RE: Application for the Necessary Zoning Approvals from the Town of Cortlandt Town Board by CVE North America to Construct and Operate a Solar Energy Production Facility on two (2) parcels of property: one parcel located west of Lexington Avenue (Tax Parcel No. 13.18-2-2.4) and a second parcel located off Red Mill Road (Tax Parcel No. 13.14-5-25) in the Town of Cortlandt, County of Westchester, State of New York.

Thereafter, at the June 1, 2021 Planning Board meeting, the Planning Board had a number of comments/questions regarding the Project (the “**Planning Board Comments**”). Listed below are each of the Planning Board Comments in bold italicized type, followed by CVE’s response in regular type.

**RE: Cortlandt Mill Solar Farm - Cortlandt Mill Westchester County, New York
Revised Visual Assessment Report**

Contract No:
360551
Scale:
AS NOTED
Date:
MARCH 2021
Sheet:
SITE PLAN
Drawing No:
4

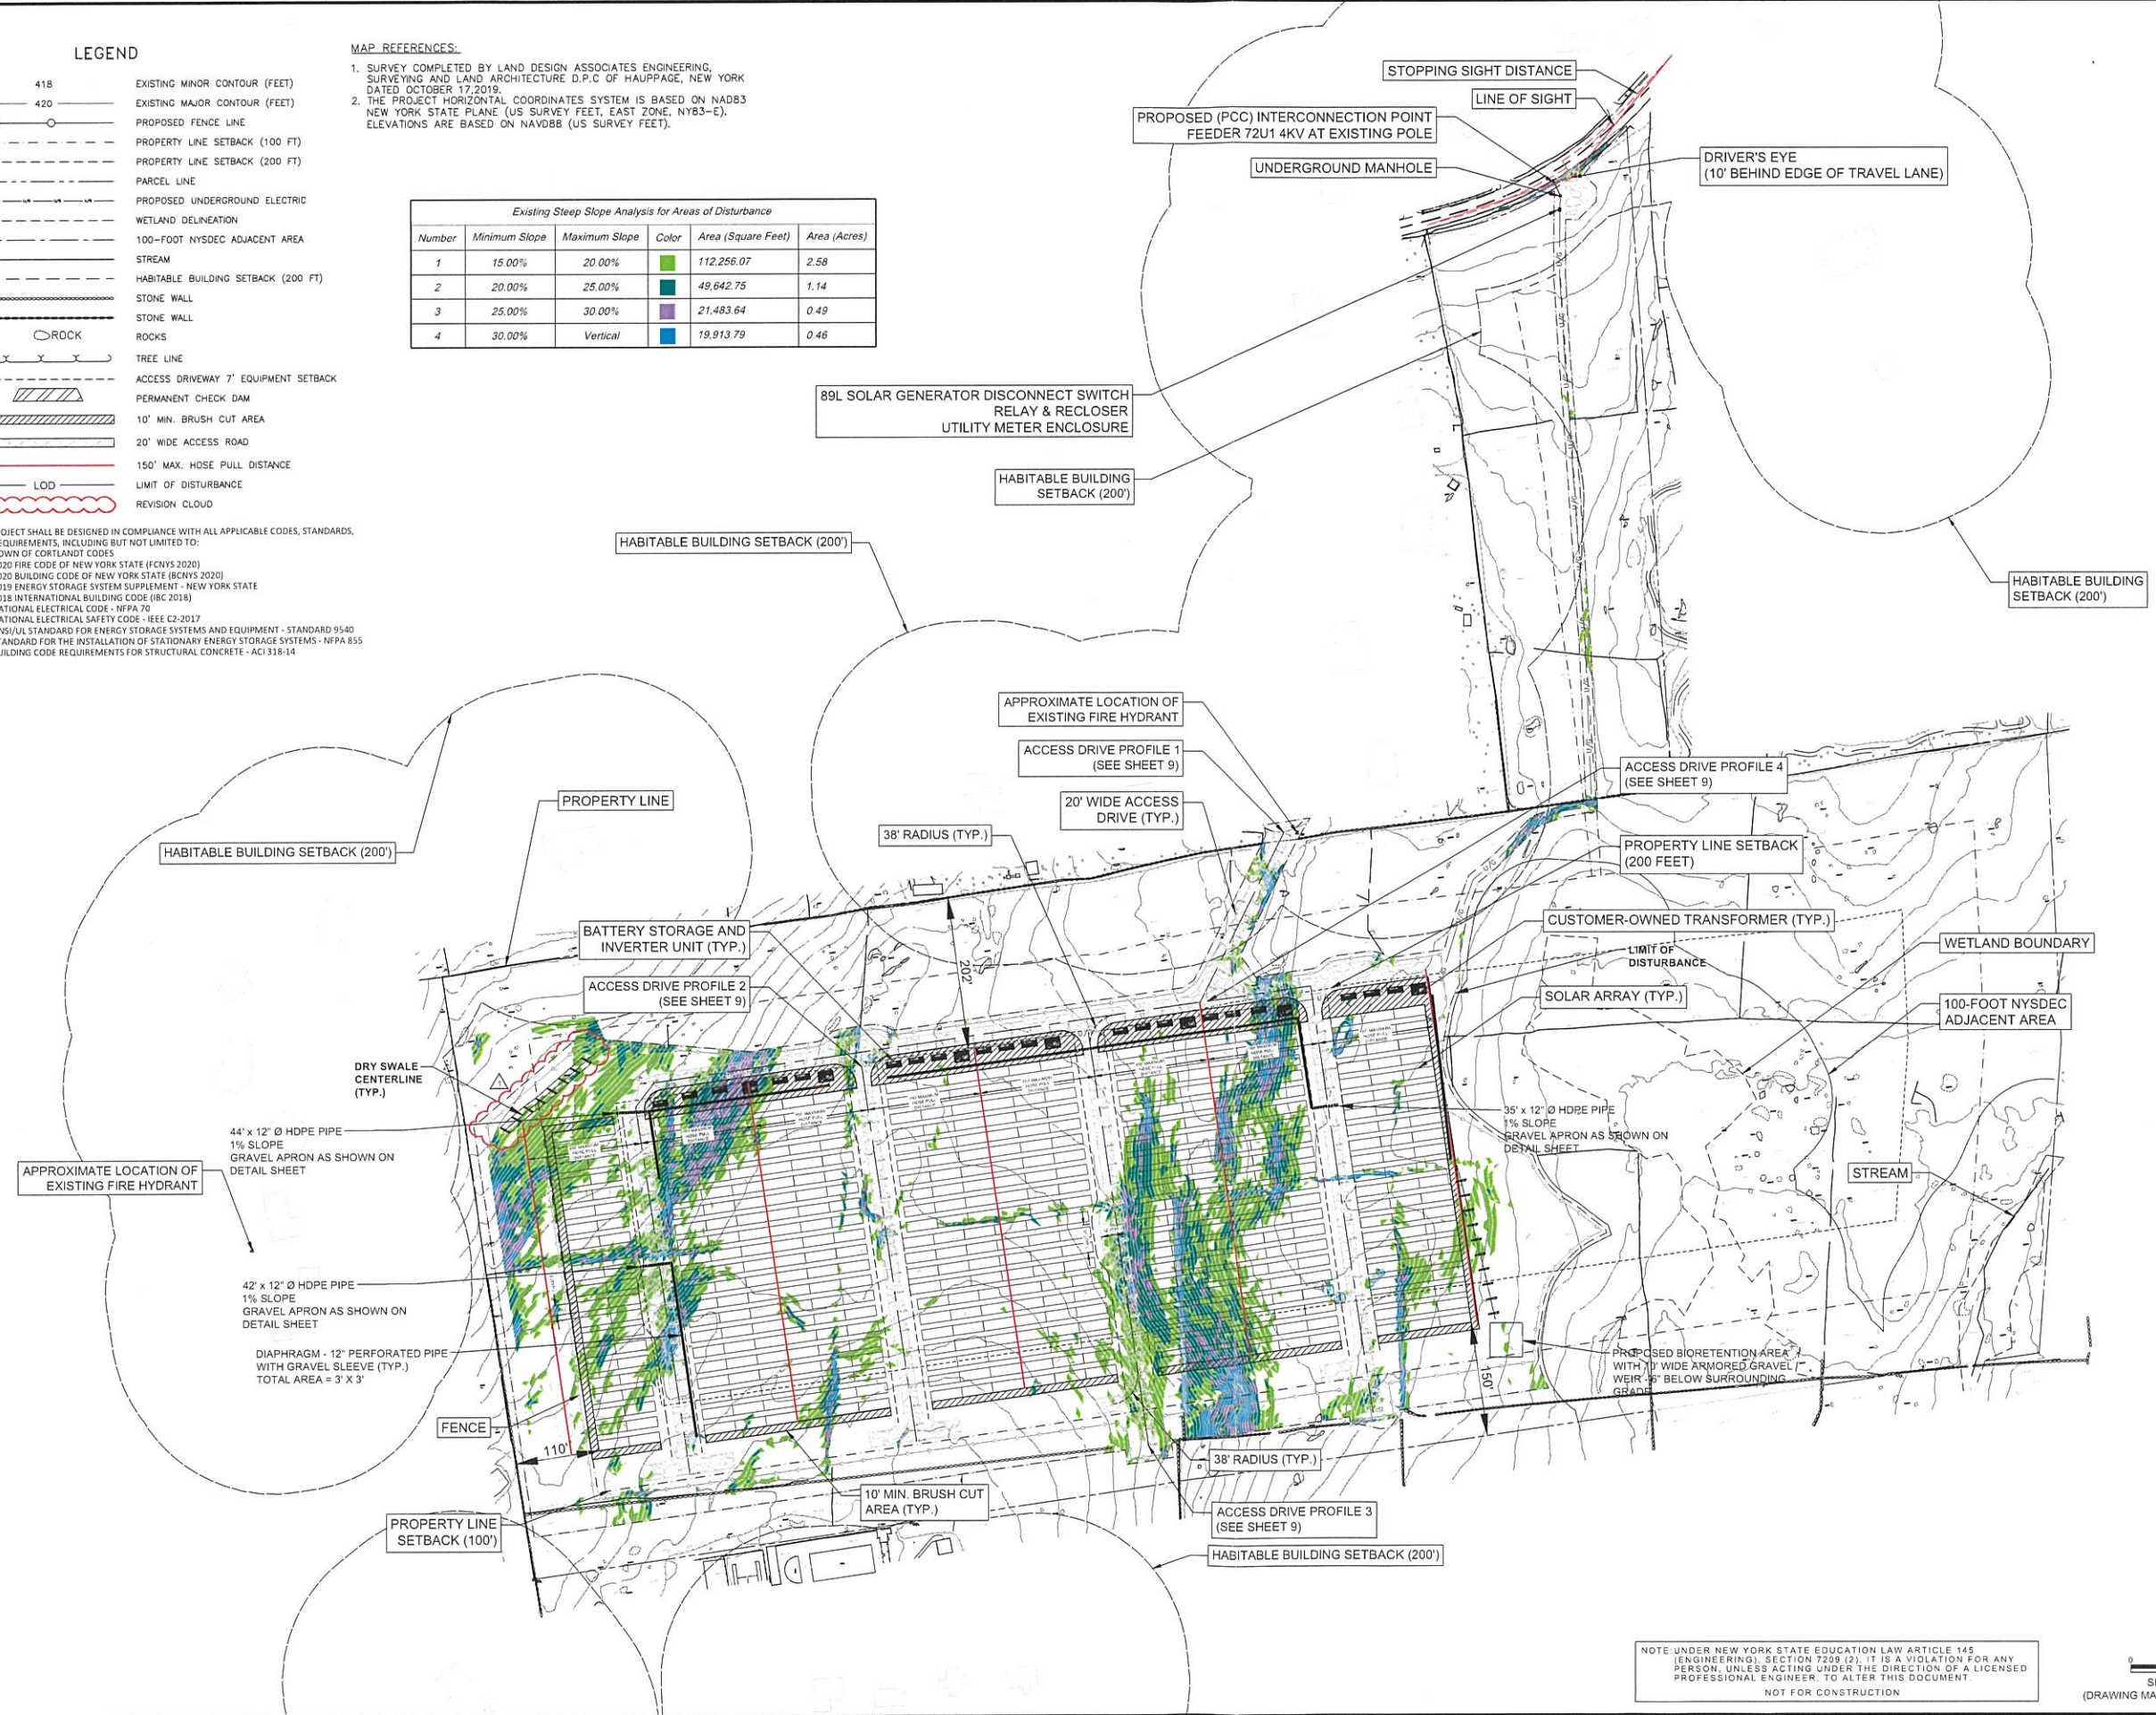
1. Please review the project design and identify ways to reduce the visibility of the panels from the homes on Mill Court.

Response: In response to this and similar comments by the Planning Board at the June 1 meeting, CVE again reviewed the project plans and made the following adjustments to the project plans, landscaping plan and visual assessment report:

- Tightened the fence line in the northwestern corner of the Project, leaving more wooded area, thus reducing the fenced-in area to 16 acres (reduced by approximately 0.3 acres), creating a wider buffer on the northwestern corner

- Reduced the height of panels to approximately 6'-10" above grade.
- Revised Site Plan Set sheets – Site Plan Drawing No. 4, revised 6/17/2021; Detail Sheet 3, Drawing No. 12, revised 6/17/2021; L-100 Landscaping Plan; and L-101 Tree Preservation and Reforestation Plan.
